ADMINISTRATIVE DETERMINATION & CERTIFICATION

FINAL PLAT

Kellyn Addition
Revised Kellyn Addition

PF-14-00143: Consider a Final Plat for Kellyn Addition, an 86 lot residential subdivision containing 40.76 acres. Lots include 15.89 acres for multi-dwelling, RM12 zoning, and 21.54 acres of proposed, and 3.34 acres of proposed RS5 located on the northwest corner of Queens Road and Overland Drive. Submitted by Grob Engineering, for Prairie Rose Holdings LC, property owner of record.

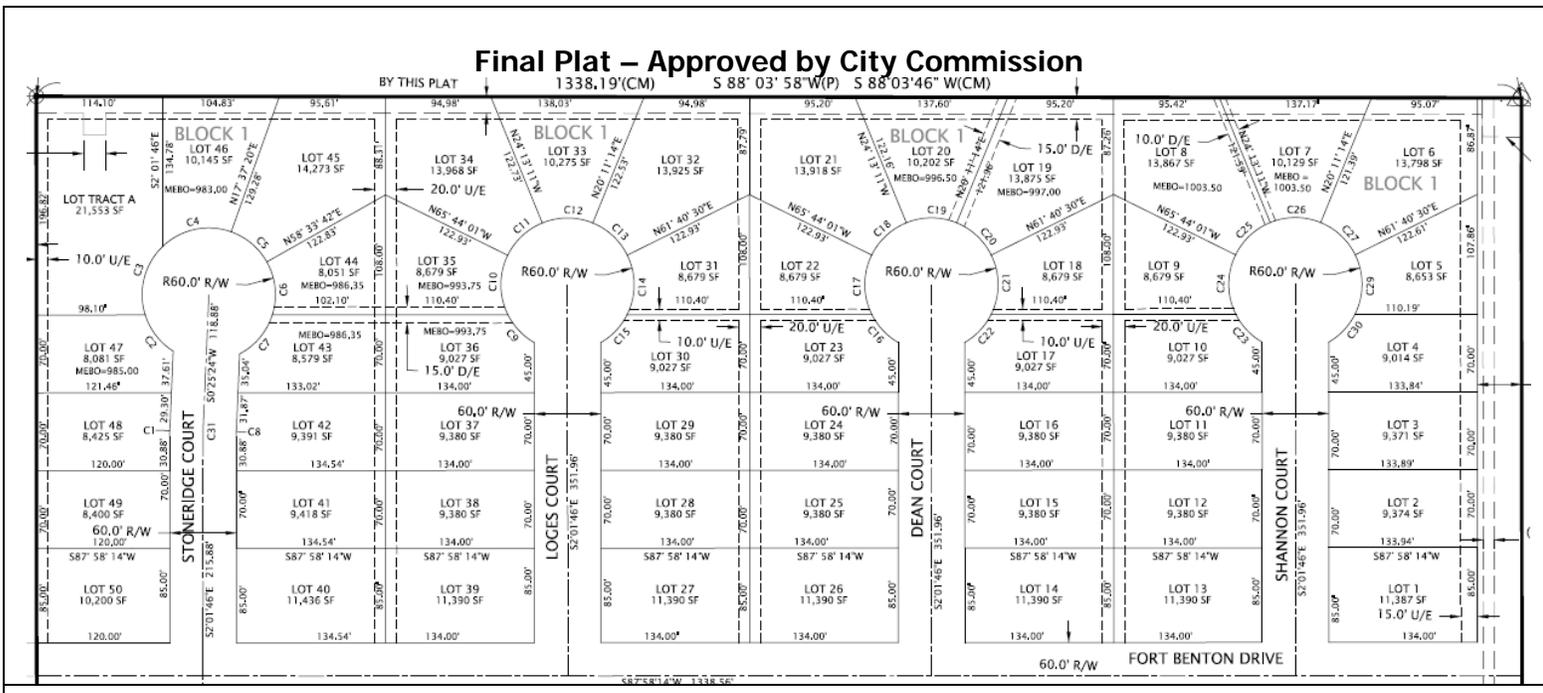
~~This property includes a detention point in the northwest corner Tract A located in Block 1. Additional detention will be required for the RM12 lot (Lot 27, Block 3) as the property~~

~~develops. The intent of this project is to convey the stormwater runoff north to the development for their use in a plan for ponds and open space. The applicant has been notified that appropriate easements and agreements are required for off-site improvements and stormwater runoff.~~

February Update: The applicant has submitted a revised drainage study to document the compliance of the proposed detention area and related easements to support this proposed development. The impact of this change is that the applicant no longer needs to execute a separate agreement with the adjacent property owner to the north. This change is reflected in the updated determination.
